UNITED STATES PATENT AND TRADEMARK OFFICE

Office Action Summary	Application No. 10/709,525	Applicant(s) DU, CHANG-LUNG	
	Examiner Lucy P. Chien	Art Unit 2871

DETAILED ACTION

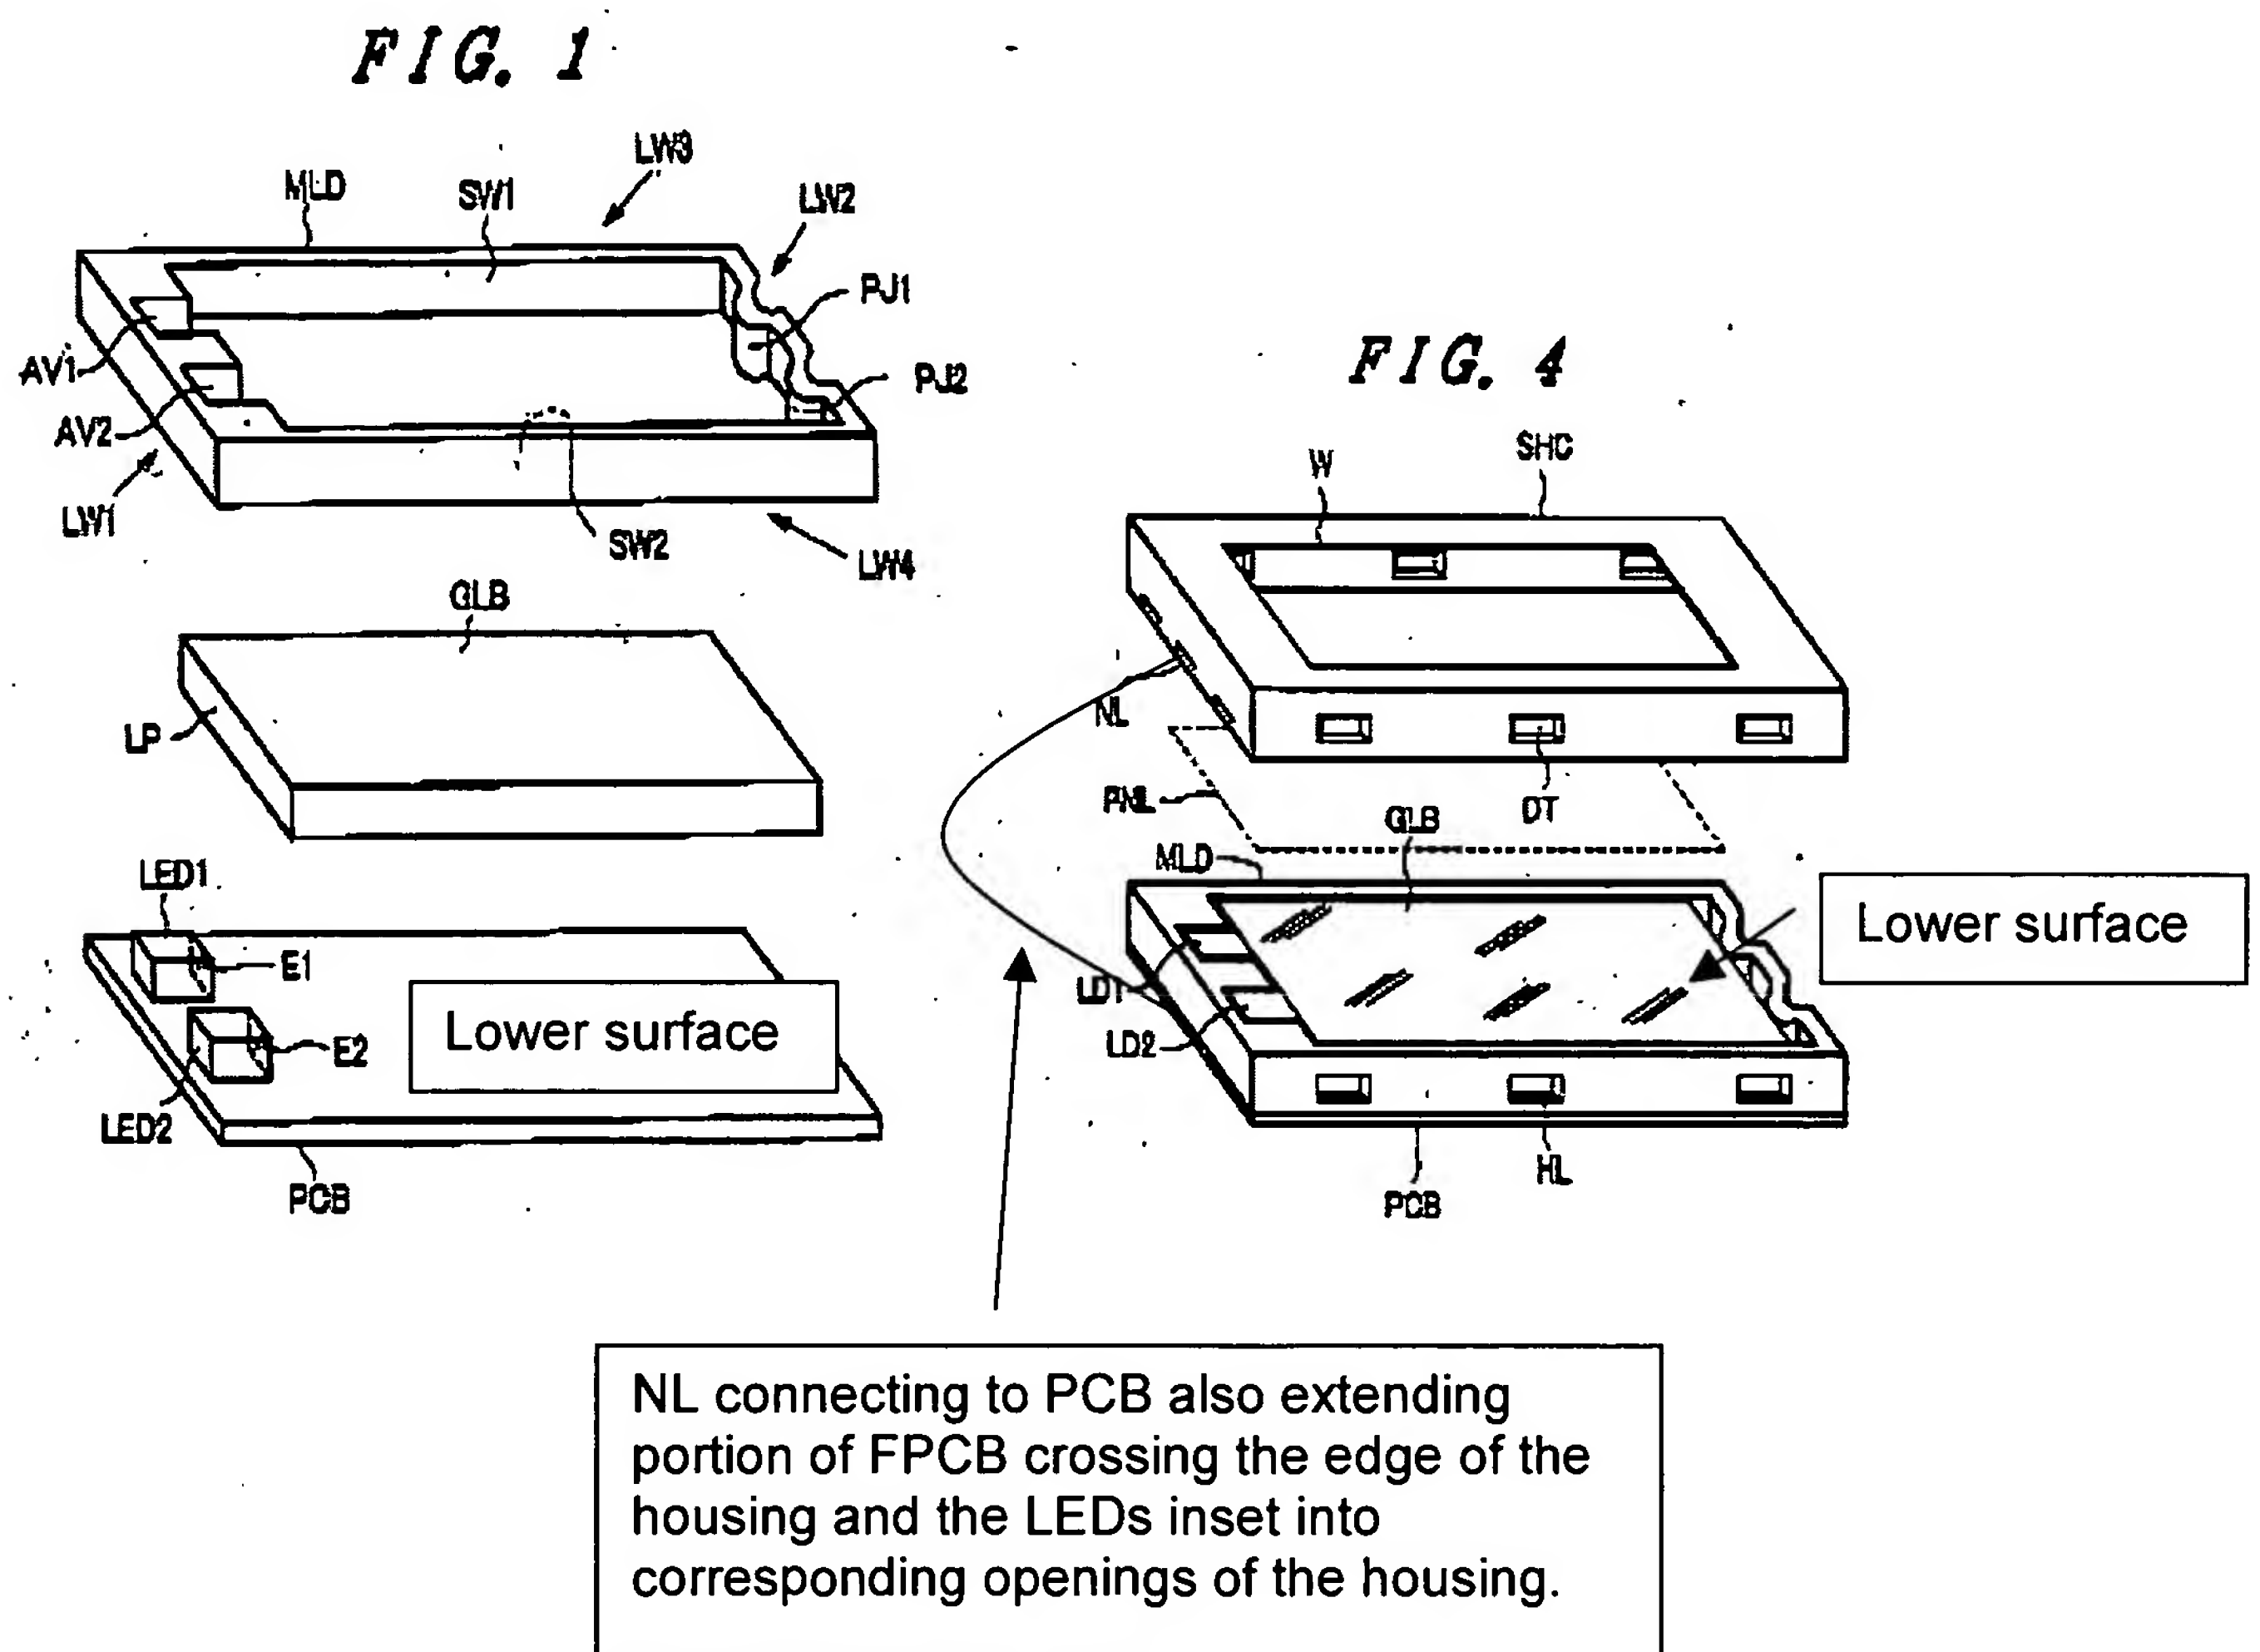
In addition to Saito et al, Kang et al, and the admission as disclosed above, Saito discloses wherein the extending portion of the FPCB crosses the edge of the housing and the LEDS inset into the corresponding openings of the housing. (shown below).

In addition to Saito et al, Kang et al, and the admission as disclosed above, Saito discloses the flexible printed circuit board (PCB) is connected to the edge of the peripheral circuit area by the lower surface of the extending portion. (shown below).

Applicant argues that "...Kang did not teach or suggest the LEDs of the FPCB would be inset into corresponding opening of the housing to be the back light source and that they didn't teach or suggest the LEDs replacing the driving IC on the flexible printed circuit board (FPCB) to a back light source or suggest the corresponding penetrating openings, which are formed in the lower surface of the mold frame, for allowing the inset LEDs to be a back light source" The Prior Art shows the FPCB but does not show it being below the LCD panel as shown in Kang. Kang shows that the Flexible Printed Circuit Board (same as the FPCB (18) of the prior art) comes from the LCD peripheral circuit area and has an extending portion that is formed below the LCD panel.

Applicant argues that Saito shows "the accommodation portions AV1,AV2 are formed in the side edge of the mold case MLD, not in the bottom." Saito shows a mold case is formed at the bottom of the LCD shown in Figure 4 (PNL).

Applicant argues that Saito teaches "the printed circuit board PCB is attached to the mold case MLD, not the LCD panel." Saito et al shows in Figure 4, the flexible printed circuit board (PCB) is connected to the LCD (PNL) (Page 4, [0048]) by the NL which is folded back towards the PCB to connect the flexible printed circuit board (PCB).

Applicant argues regarding Claim 8 that Saito teaches "driver ICs and other electronic components are mounted on the back surface of the printed circuit board with the LEDs being mounted on the opposite face" Saito discloses that a plurality of electrical components formed below the lower surface of the FPC (shown below).
